Subject: Class II Permissive Change to Transmitter with FCC ID: UZ7AP7131N

Software Changes to eliminate Beacon delay in AP7131N

Timeline for Post-Radar detection events

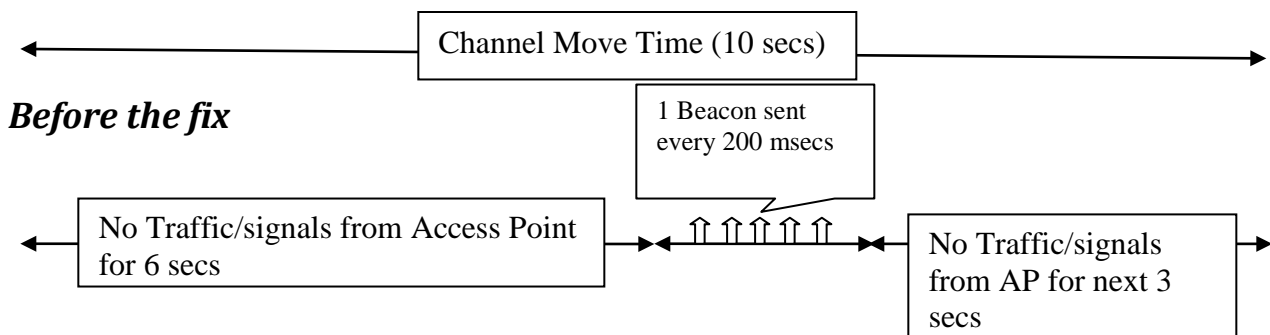
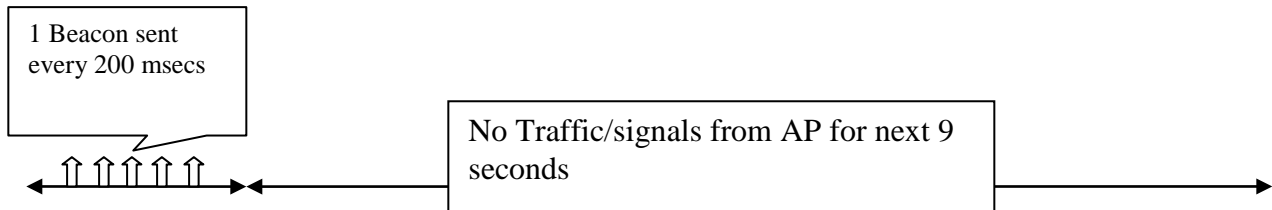
The changes for this update happened in the Beacon management module which had an issue that caused it wait for 6 seconds before updating the beacon contents, while permissible under FCC rules; it causes an unnecessary reduction in throughput in the event of a radar detection occurrence. With the fix in beacon management module, the 6 second delay is removed. No changes in Radar Detection Module or Channel Management Module were made

Upon a successful Radar detection, the AP stops data traffic immediately and has 10 seconds to complete the 'Channel Move Time'. Within these 10 seconds, the Access Point sends 5 beacons with the channel switch announcement information indicating to the clients the new channel. The beacons were sent after a 200 millisecond interval with the total duration of this beaconing sequence completed within 1 second. For channel closing time calculation: Beacons are 100 bytes long, sent at 6 Mbps; the total transmission time for the 5 beacons is 0.65 milliseconds, which is much less than 200 milliseconds requirement.

The fix is to change the time of commencement of those 5 beacons within the 10 second Channel Move Time window, with no impact to Channel Closing Time.

After the fix
